**Si3402-A-GM to Si3402-B-GM EVB Modifications
Version 0.4**

The Si3402-B-GM device requires component value changes from those used with the Si3402-A-GM evaluation board (EVB) reference design. Table 1 below is a summary of the required modifications.

Si3402 (Buck, Non-Isolated) EVB Reference Design - 5V

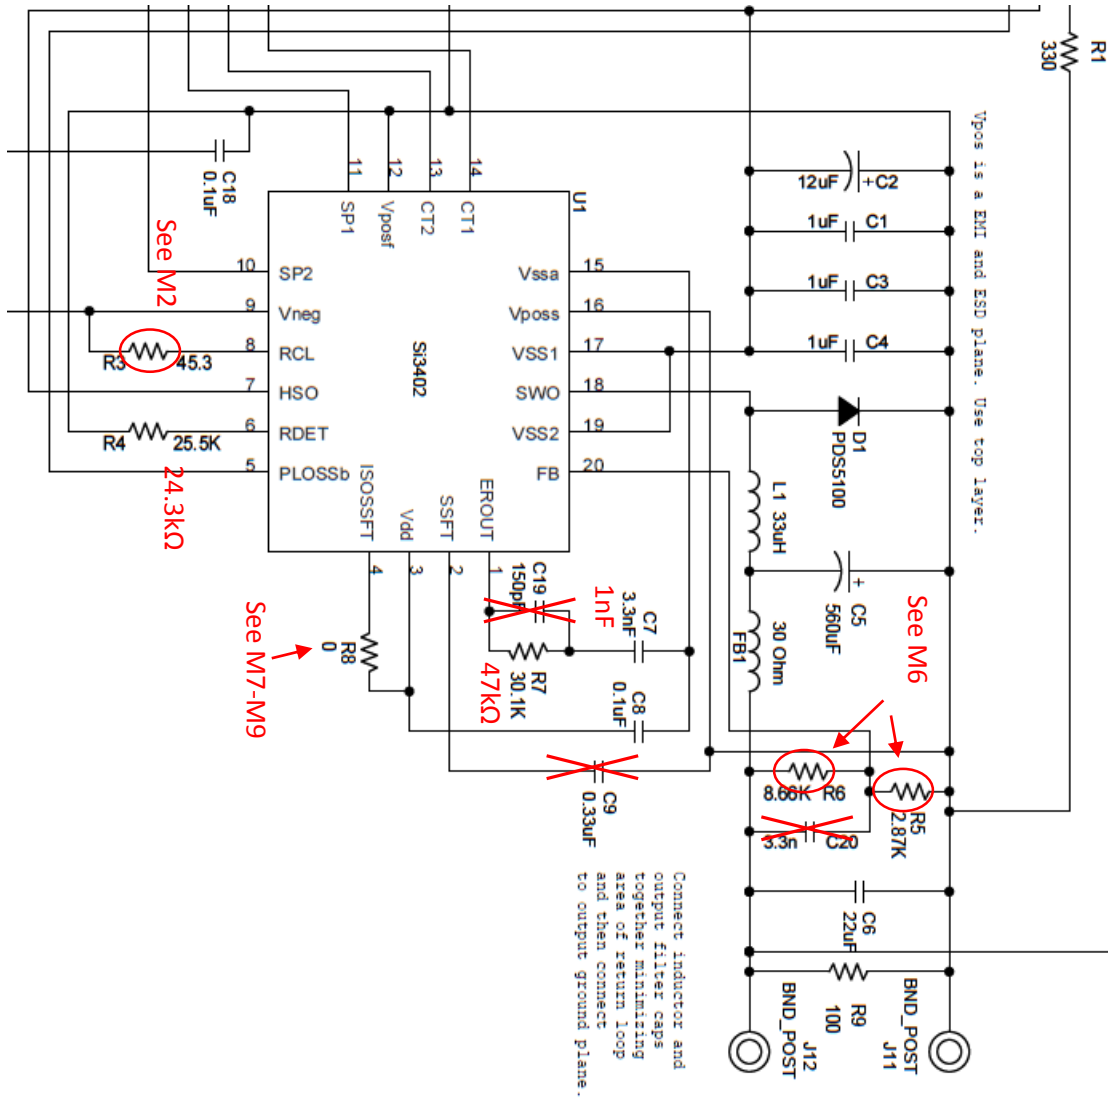
Following Table 1 are two reference schematic excerpts showing the locations of the modified component values for both the isolated (flyback) and non-isolated (buck) topologies.

Item	Modification description	Application design effect
M1	Detect resistor value change	The former 25.5kΩ detect resistor must be replaced by 24.3kΩ 1%
M2	Classification resistor value change	The following 1% resistors must be used: Class0: 681.00 or higher (It is optional to place this resistor) Class1: 140.0 Class2: 75.0 Class3: 48.7 Class4: 33.2
M3*	ISO EVB DCDC 3.3V changes Flyback	C8, R9 & C23 are not need—Do not populate them. C9=10nF, C21=33nF, R12=475 Ω & R8=1.1k Ω Replace D2 (DFLT15A) with DFLT30A * See Revision Notes
M4	ISO EVB DCDC 5V changes Flyback	C8, R9 & C23 are not need—Do not populate them. C9=3.3nF, C21=15nF, R12=0 & R8=0 (place zero Ω resistors) Replace D2 (DFLT15A) with DFLT30A
M5	ISO EVB DCDC 12V changes Flyback	C8, R9 & C23 are not need—Do not populate them. C9=10nF, C21=15nF, R12=0, R8=0 (place zero Ω resistor) R7=3k Replace D2 (DFLT15A) with DFLT30A
M6	DCDC reference voltage change (Buck case only)	Now 1.35V instead of previous 1.23V. Thus, R5 changes from 2.87kΩ 1% to 3.24kΩ 1%. R6 (1%) is modified according to this table:

Vout Target	R5 kΩ	R6 kΩ	Vref	Vout Measured
		3.3	3.24	4.64	1.35	3.37
		5	3.24	8.66	1.35	4.96
		9	3.24	18.2	1.35	8.93
		12	3.24	25.5	1.35	11.98
M7	BUCK EVB DCDC 3.3V compensation network changes	C19, C20 & C9 are not need—Do not populate them. R8 can be populated with a 0Ω resistor (creating a short between pins 3 and 4) or left unpopulated, since the ISOSSFT function is now internal (see datasheet). C7=1nF, R7=47kΩ ±20%.				
M8	BUCK EVB DCDC 5V compensation network changes	C19, C20, R8 & C9 are not need—Do not populate them. R8 can be populated with a 0Ω resistor (creating a short between pins 3 and 4) or left unpopulated, since the ISOSSFT function is now internal (see datasheet). C7=1nF, R7=47kΩ ±20%.				
M9	BUCK EVB DCDC 12V compensation network changes	C19, C20, R8 & C9 are not need—Do not populate them. R8 can be populated with a 0Ω resistor (creating a short between pins 3 and 4) or left unpopulated, since the ISOSSFT function is now internal (see datasheet). C7=1nF, R7=47kΩ ±20%.
